<b>Subject:</b> X12 Alternator Cable Support Bracket Shim Retrofit			
<b>Field Change Program:</b> Field Campaign	<b>FCP Number:</b> 484	<b>Revision:</b> A	<b>Date:</b> 09/17/2020
<b>Coach Section:</b> 07- Electrical	<b>P/N:</b> 07-10-0023		<b>Type:</b> Product Integrity

Motor Coach Industries (MCI) has become aware that, on certain J4500 and D45CRT-LE, coaches equipped with Cummins X12 engine, the top alternator power and ground cables may potentially come in contact with the edge of the clamp mounting bracket.

ITEM	PART NO	QTY	U/M	DESCRIPTION
1	07-10-2327	1	EA	Spacer- Bracket assy, Alt. Top, Gnd and Pwr Cable

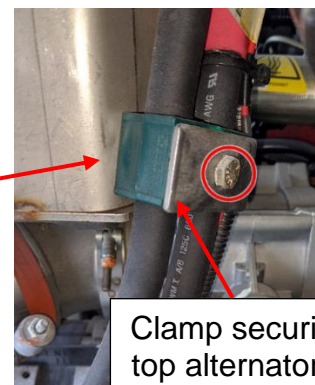
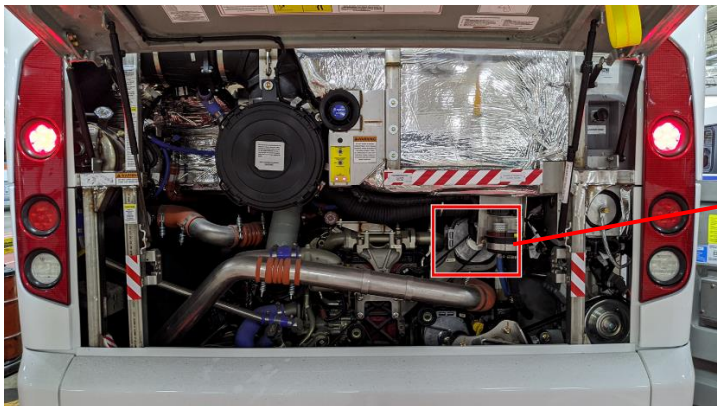
MCI recommends owners of the affected coaches have the following procedure performed to add a shim between the mounting bracket and the clamp.

Loosen the bolt

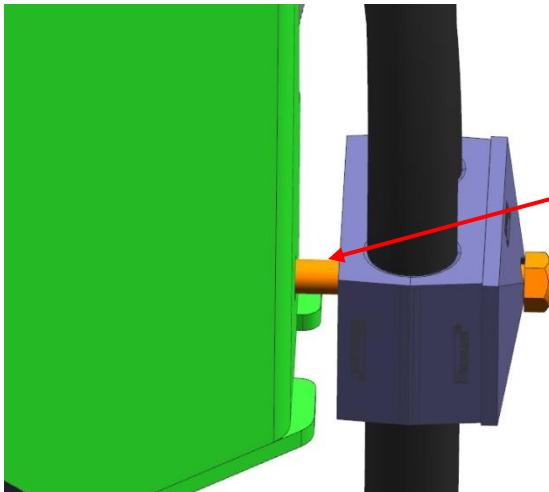
Loosen the bolt securing the clamp. Ensure not to remove the bolt completely.

Apply Loctite 243,  
23-02-0088

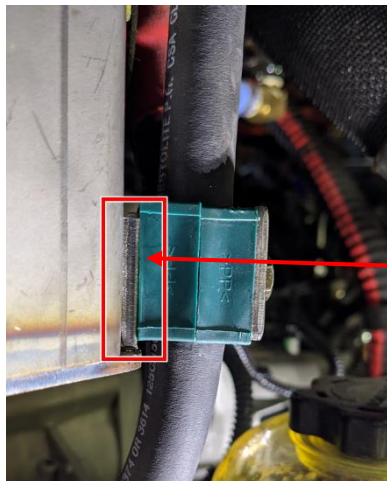
Apply Loctite 243, MCI P/N: 23-02-0088, on the exposed threads.
